Addendum No.: 01

Date Of Addendum: 3/16/2021

**BUSINESS SCHOOL INSTRUCTIONAL FACILITY
SOUTHERN CT STATE UNIVERSITY
BI – RS– 337**

The following clarifications are applicable to drawings and specifications for the project referenced above.

ADDENDUM 01: CROSSWALK DETAIL
 BUSINESS SCHOOL INSTRUCTIONAL FACILITY
 BI-RS-337
 10 WINTERGREEN AVENUE
 NEW HAVEN, CT

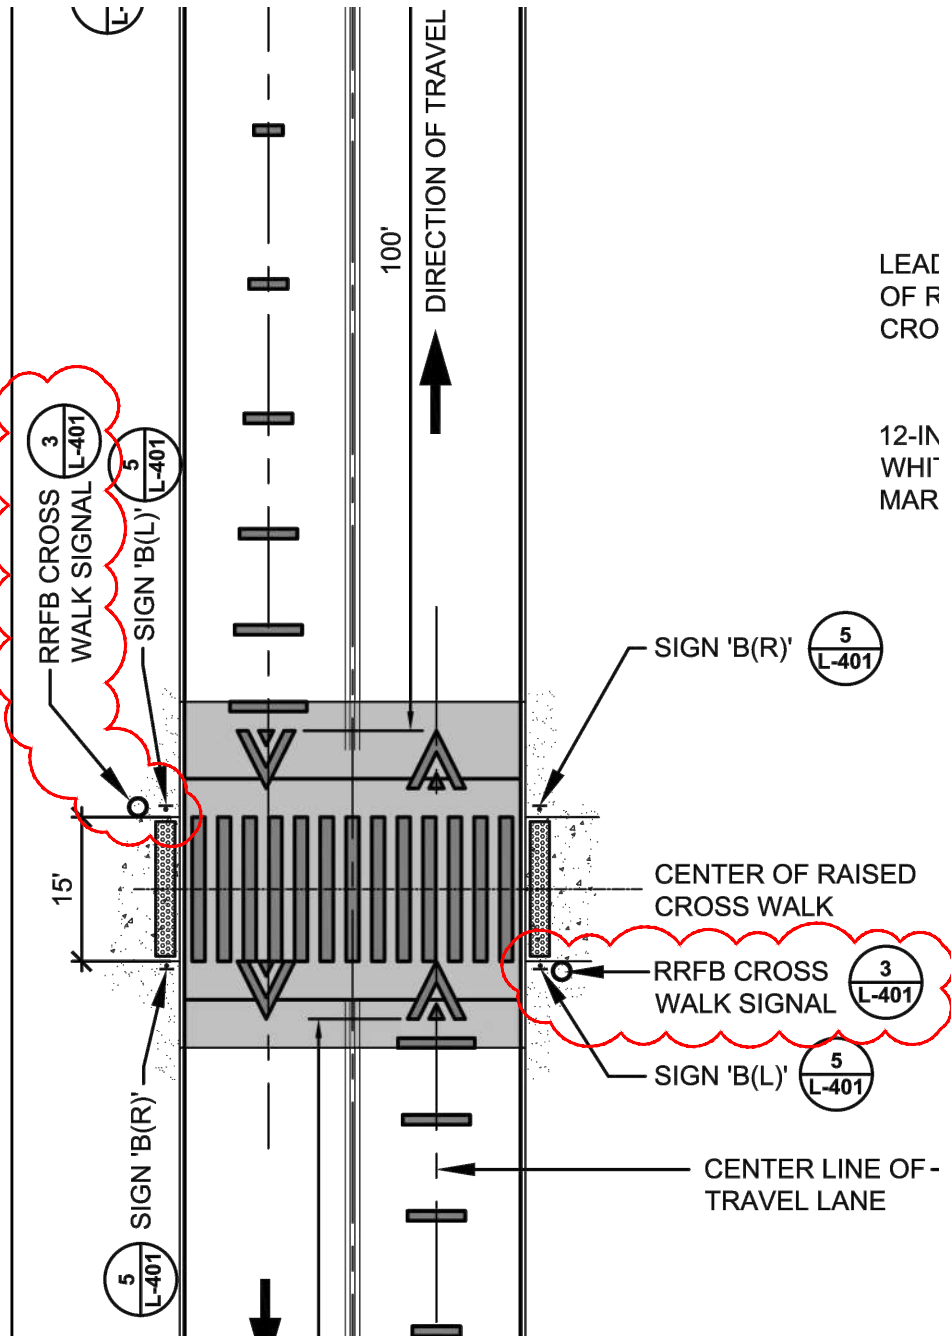
B-SKL-08: RRFB poles moved to opposite side of approach walk

1. LOCATION OF RRFB REVISED
2. DETAILS 3 AND 5 - ALL CROSS WALK SIGNS TO BE FLUORESCENT YELLOW/GREEN WITH BLACK BORDER AND LETTERING
3. DETAIL 4 ALL CITY TRAFFIC SIGNS REMOVED AND TO BE REINSTALLED SHALL USE THE VLOK POST SYSTEM

1 SITE PLAN
E-011 SCALE: 1" = 50'-0"

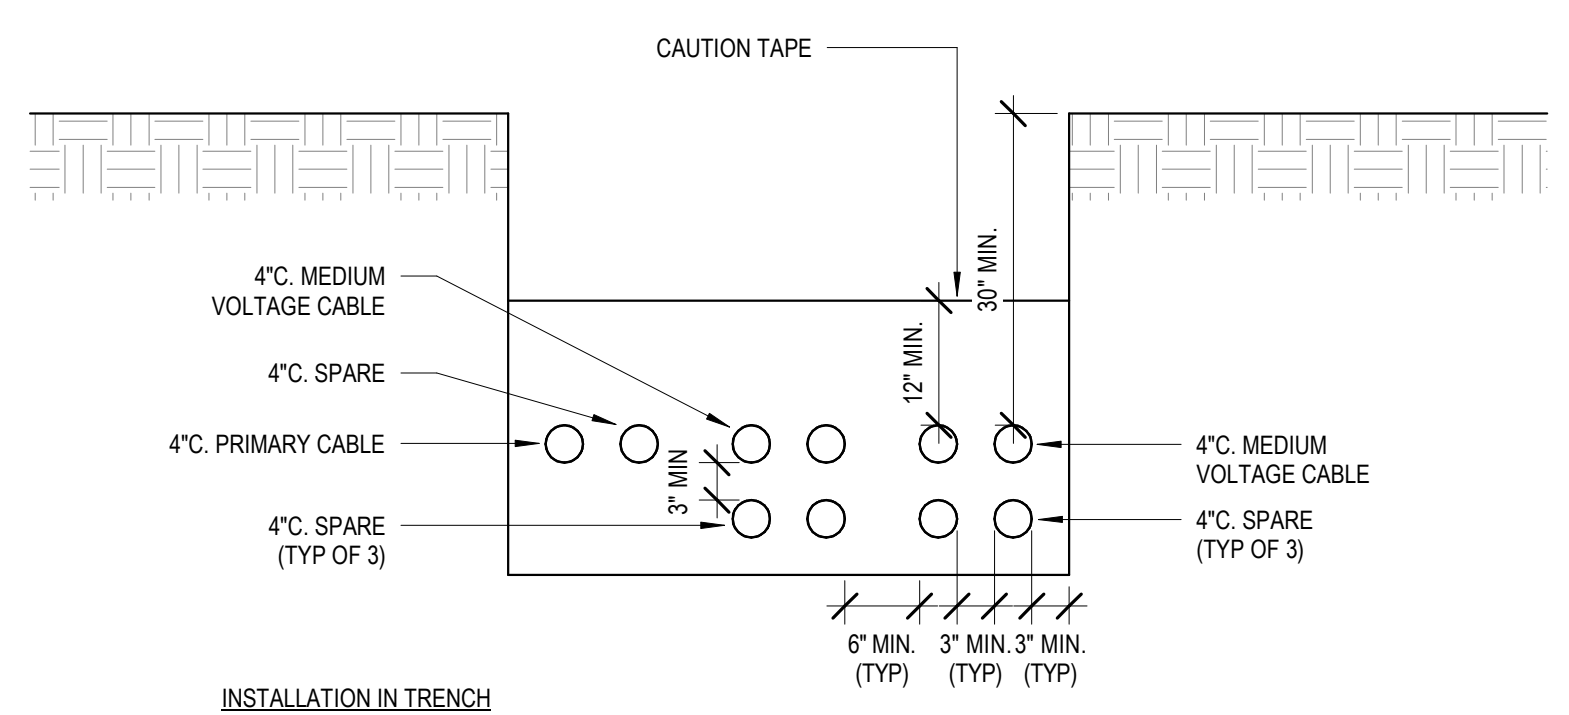
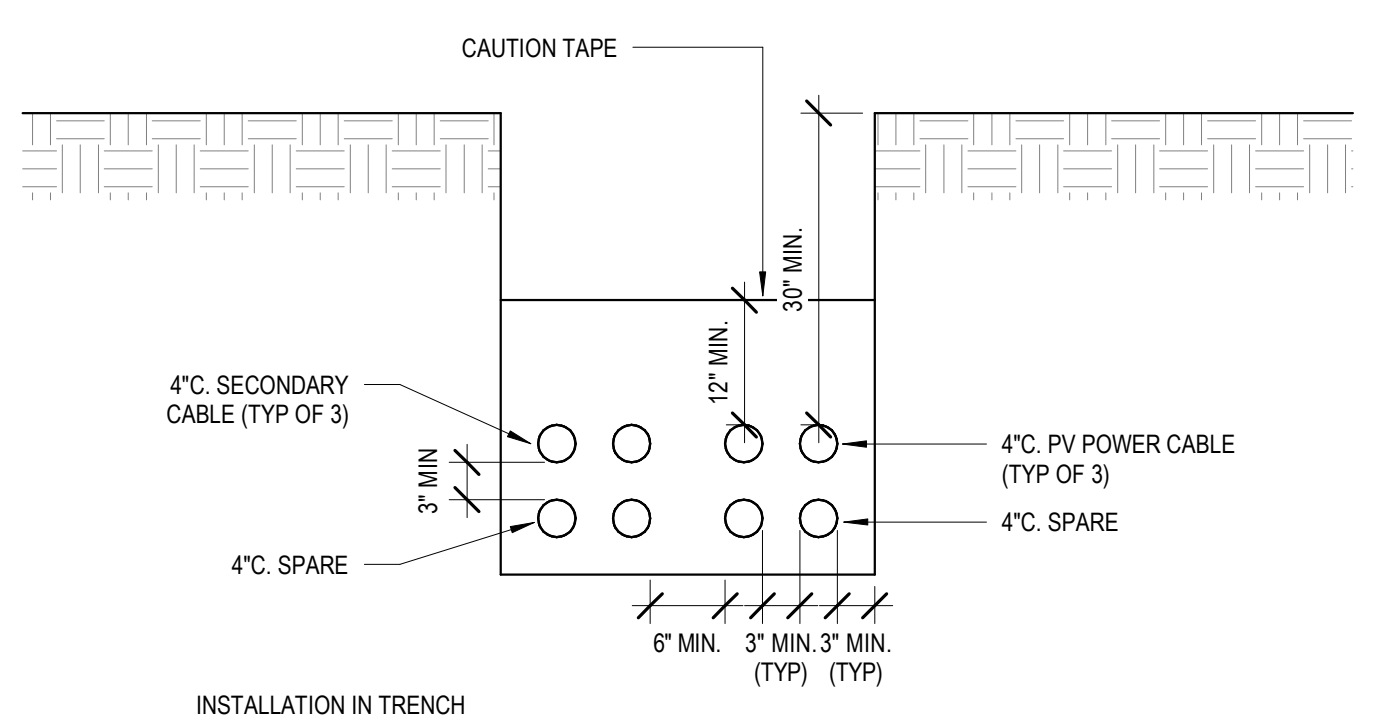
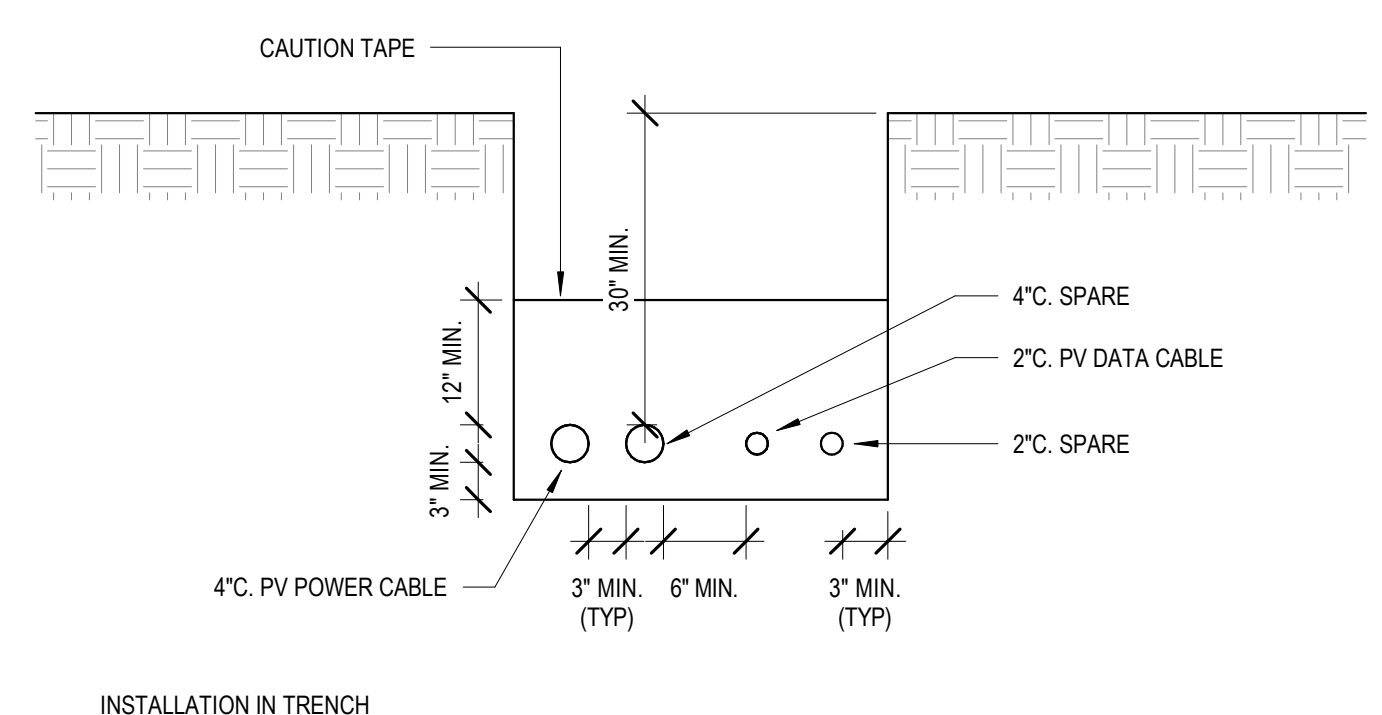
On drawing E-011, revised PV ductbank routing to avoid tree protection area and revised medium voltage ductbank routing.

B-SKE-01

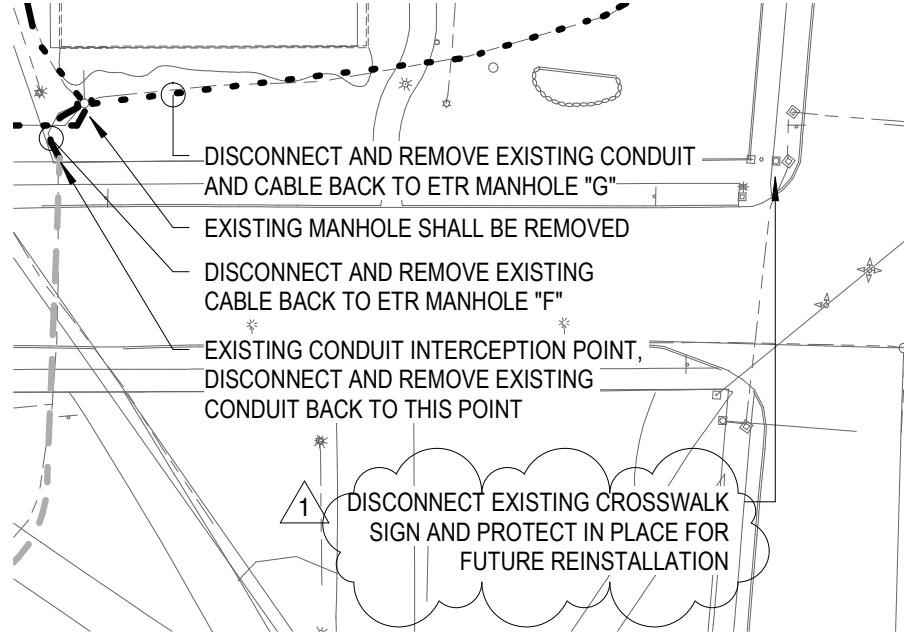
Refer to sketch B-SKE-01: reference drawing E-010, revised note to protect existing crosswalk sign in place.

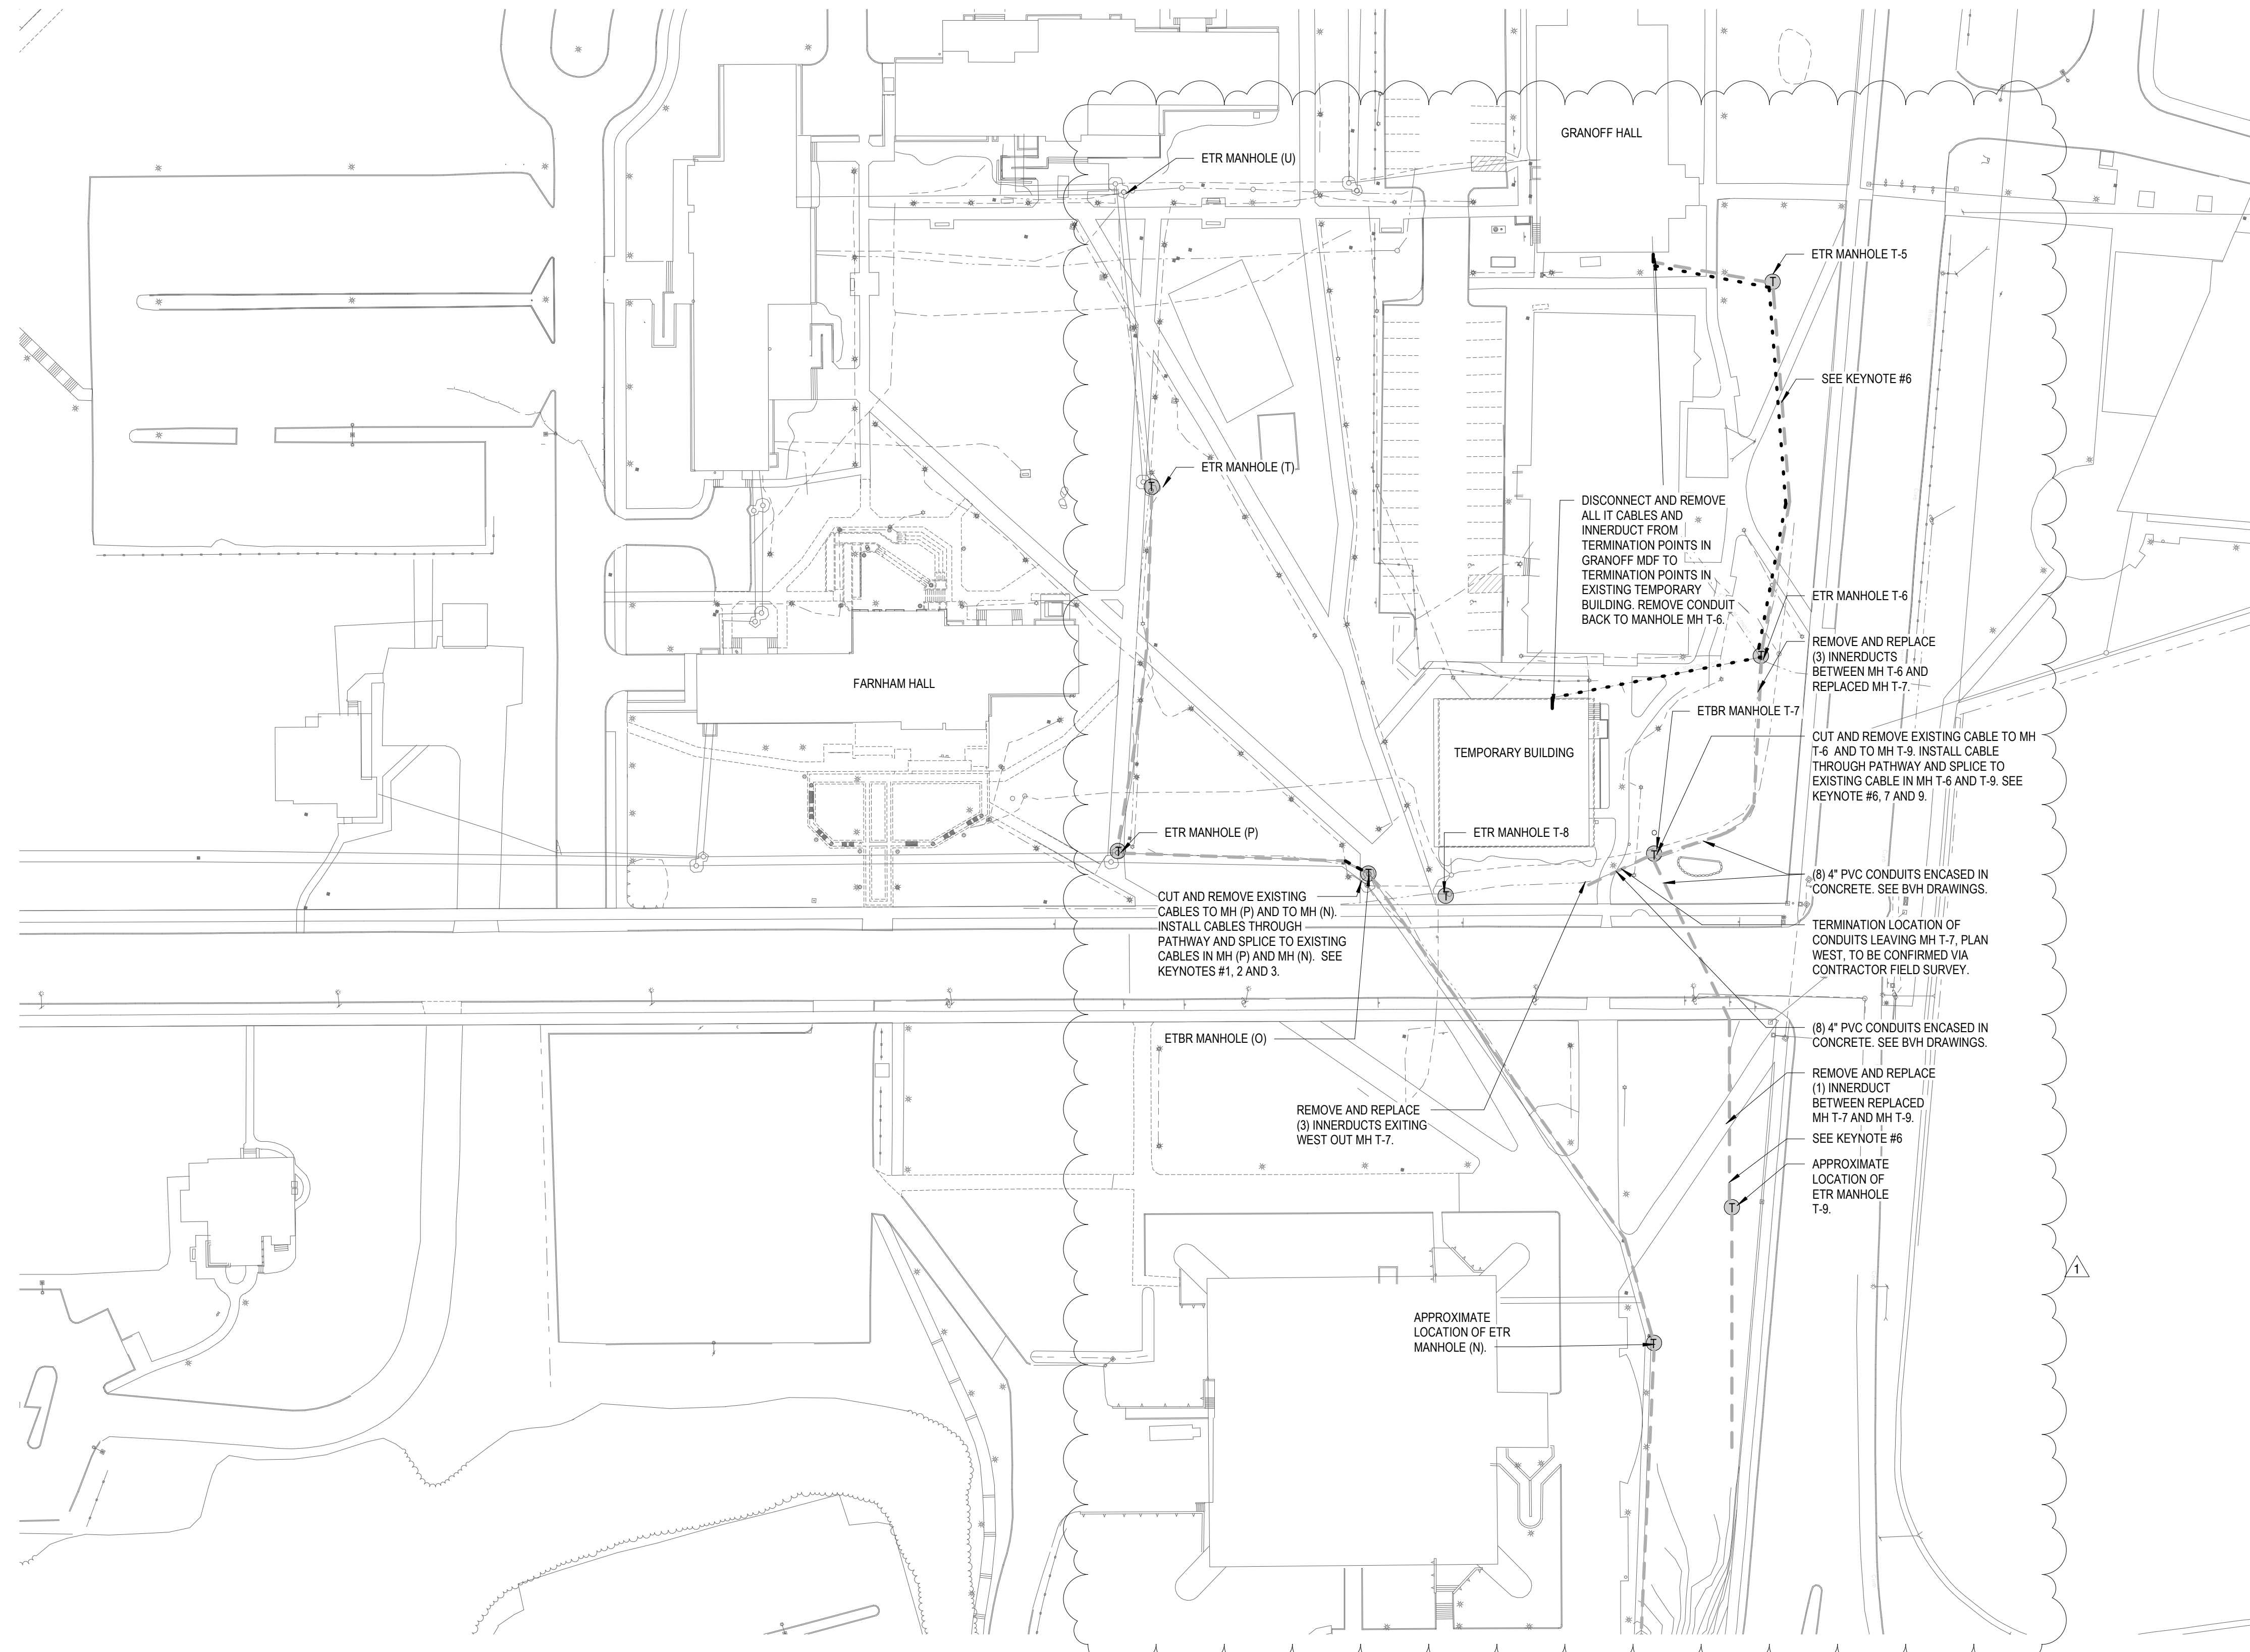
On drawings IT-010, revised scope of IT manhole work and reference notes.
